F. No. 19-23/93-CZA(256)(Vol.III)(M)

DATE: 25.1.2008

**Sub:- Designs submitted for the proposed construction of Clouded leopard, Pig tailed macaque, Spectacled langur and Binturong as part to ongoing Conservation Breeding Programme at Sepahijala Zoo, Sepahijala, Tripura.**

## 2. Enclosure for Binturong enclosure

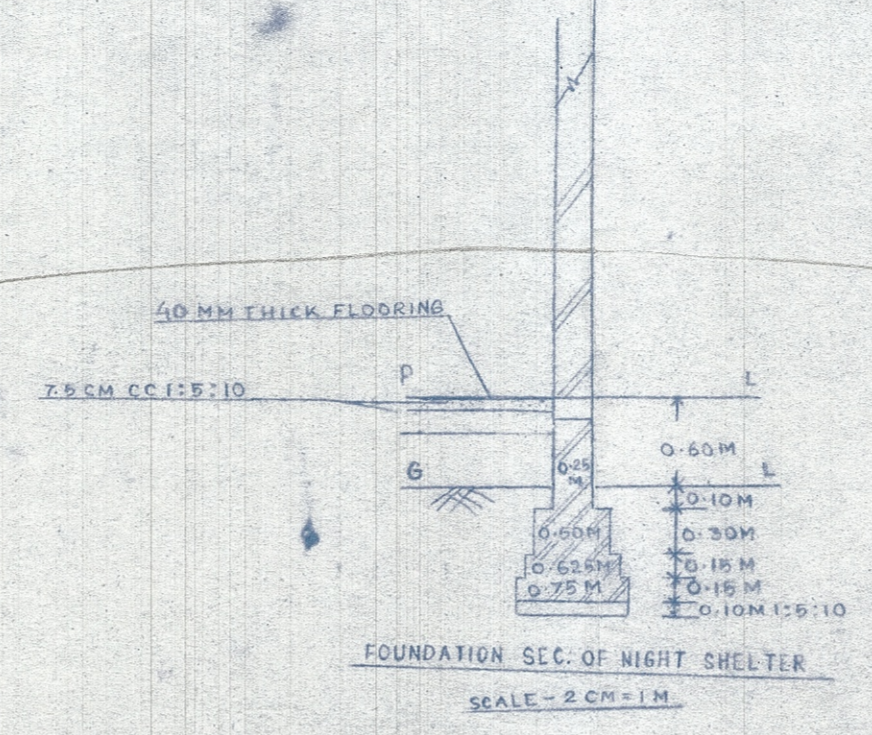
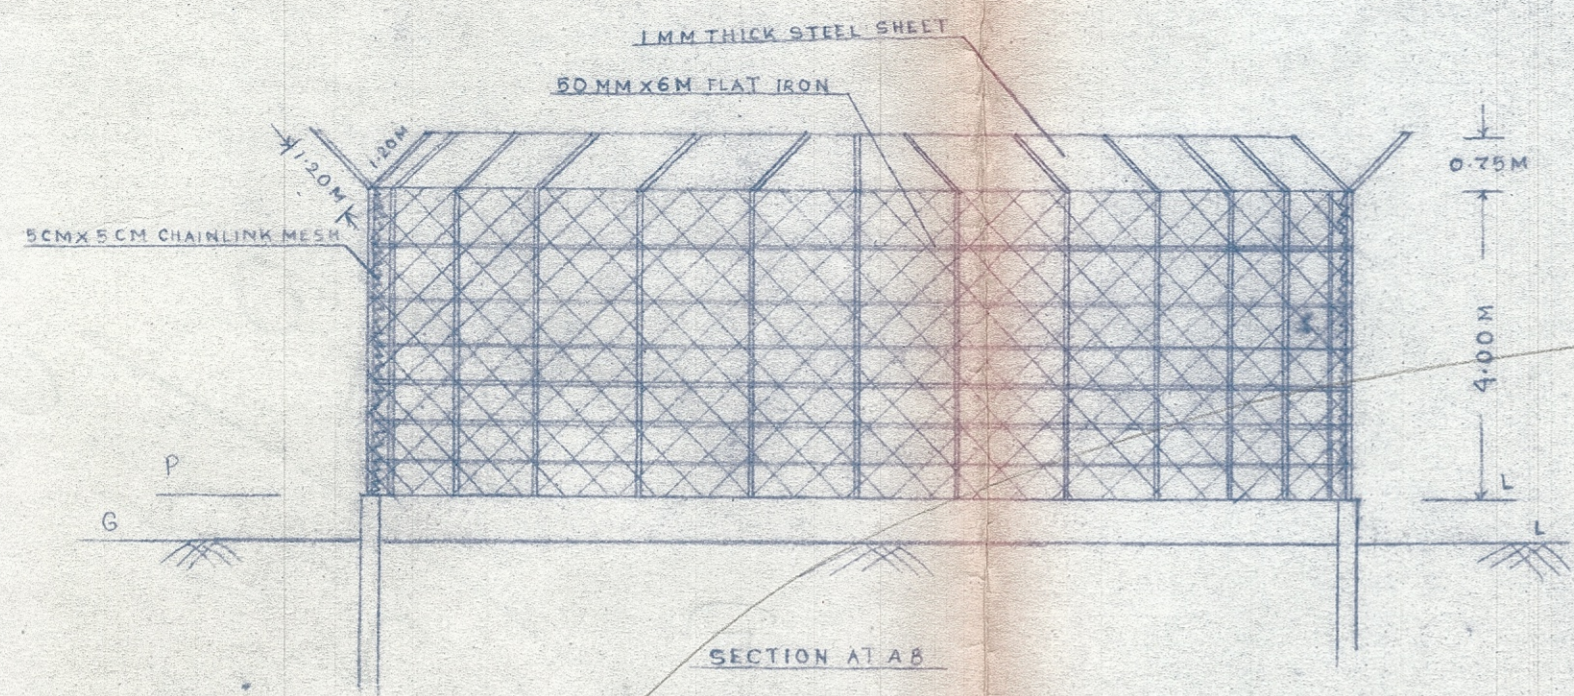
The Members did not approve the design. However, the Members suggested that the height of the chain link mesh barrier should be reduced to 2.5 meters with inclined inward steel plate of 1 meter width on the top. The steel plate should be placed at the angle of 60 degree.

Keeping in view of the above, you are requested to submit a revised design along with estimate to this office for further consideration of this Authority.

CONSTRUCTION OF SPECTACLED LANGUR ENCLOSURE WITH NIGHT SHELTER  
 ROOM FOR CONSERVATION BREEDING PROGRAMME & QUARANTINE ENCLOSURE AT  
 SEPAHJALA ZOO.

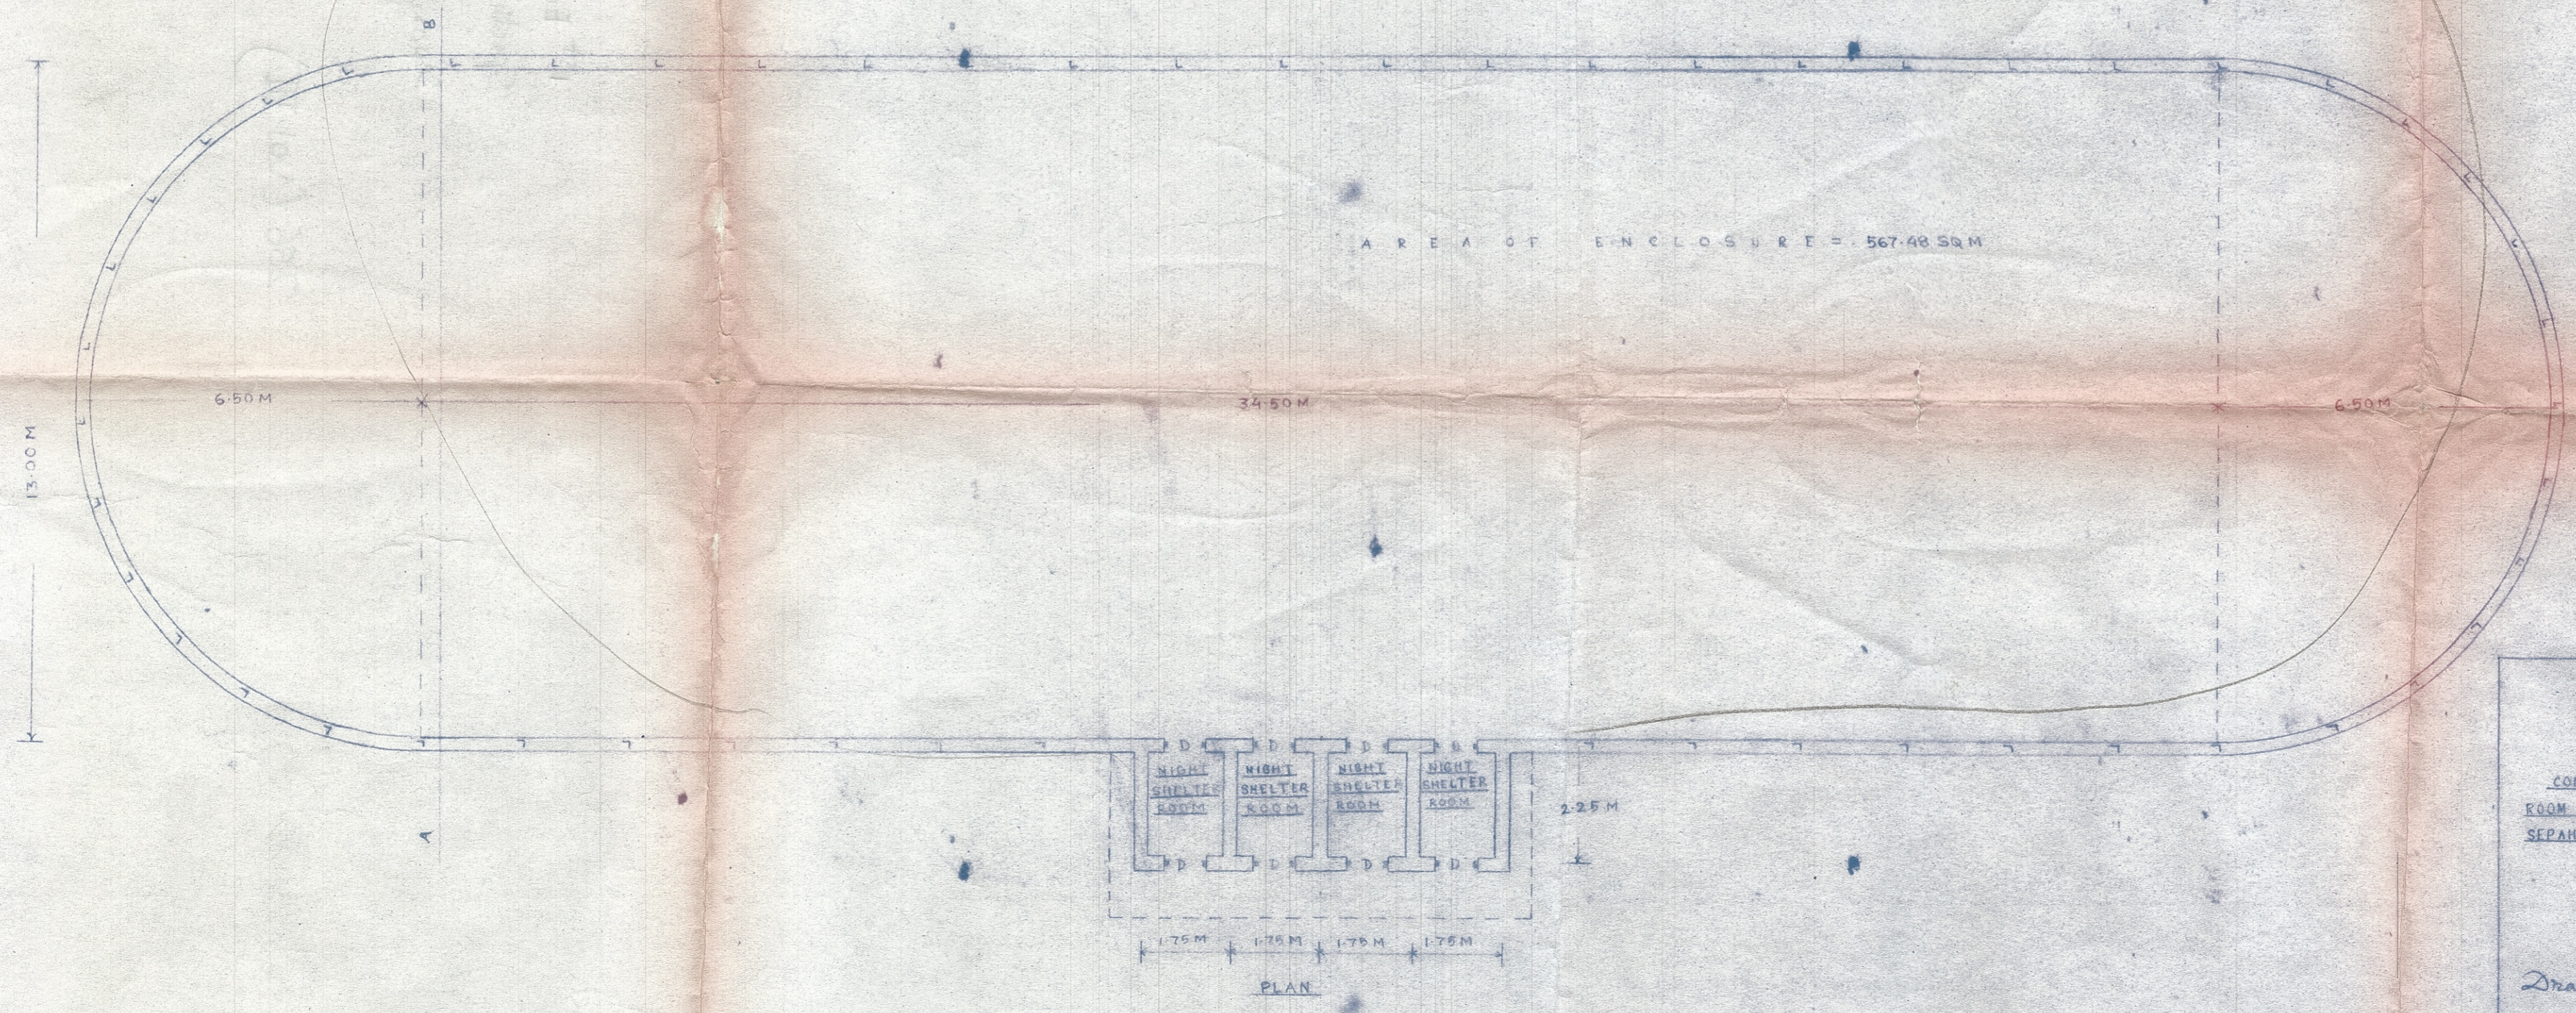
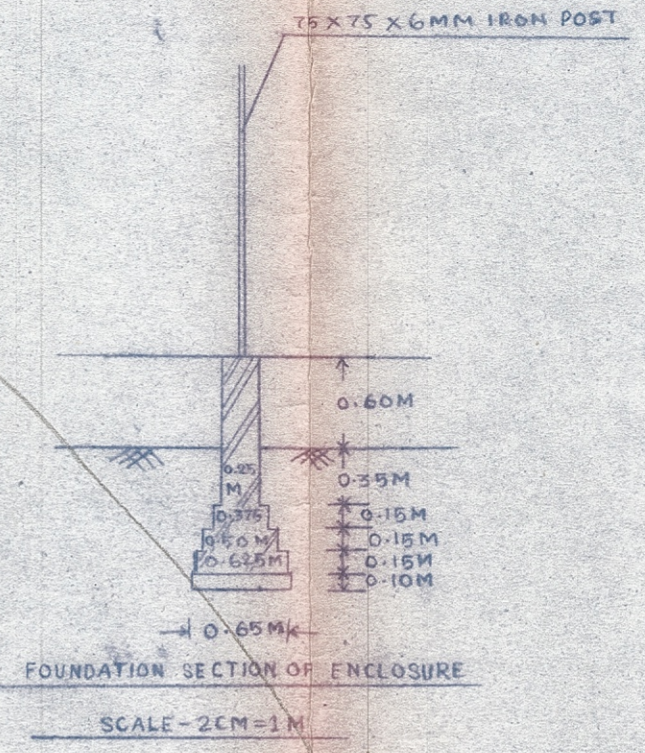
1. **Enclosure for Clouded leopard, Pig tailed macaque & Spectacled langur**

The Members approved the designs subject to that the following amendments should be made:-

- (i) The minimum width of all the enclosures should be increased to 25-30 meters, keeping in view of the available area.
- (ii) The width of the proposed inward inclined overhang with steel plate should be made of minimum 1.25 meters.
- (iii) The provision of attached/ associated toilet in project office should be made.
